RECALL

PART NAME & DESCRIPTION: HONDA MOTUS Motorcycle Lift

PART NUMBER(s): Model: PSM 0.5S
Units Manufactured in 2001

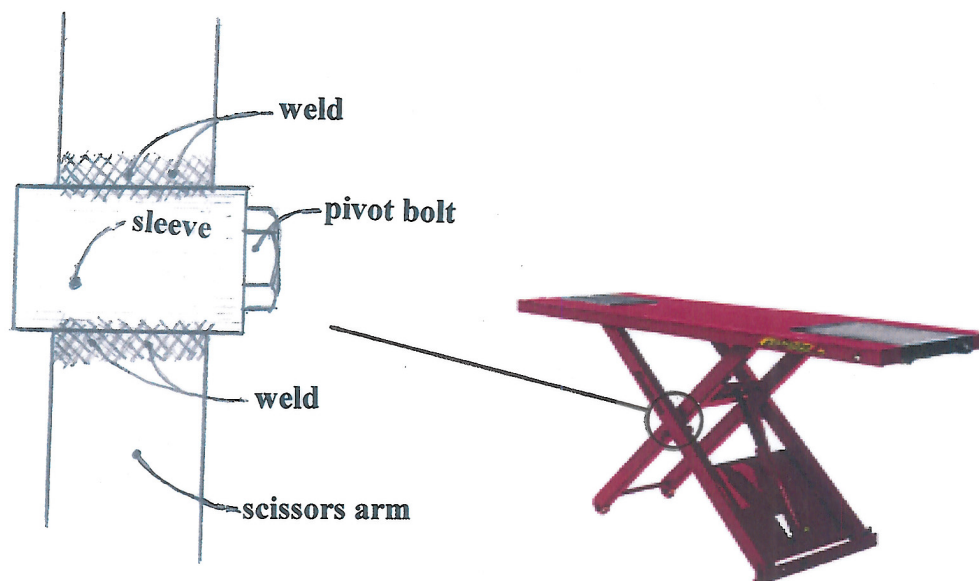
The weldments that attach the sleeves (for the pivot bolts) to the scissors arms may develop a crack. If the crack expands and fractures completely through the welded joint, the lift may collapse under load causing serious bodily injury to the lift operator and / or others in the vicinity and / or damage to the motorcycle.

The following photograph and sketch illustrate the location of concern.

1. Inspect the weldments (2 welds on each sleeve on each of the 4 scissors arms) for cracks. If there are any cracks DISCONTINUE USE immediately.
2. All of the model PSM 0.5S lifts manufactured in 2001 must be replaced, even if there are, presently, no weld cracks or if the lift has been re-welded. A new lift, model KLS356350B2, will be furnished at no cost to you, as a replacement. Specifications and information about the KLS356350B2 Heavy-Duty Motorcycle Air Lift w/Fast-Mount Side Panel Set can be found in HONDA'S interactive Network (iN). Go to iN: Service/Tools and click on "Tool and Equipment Program".
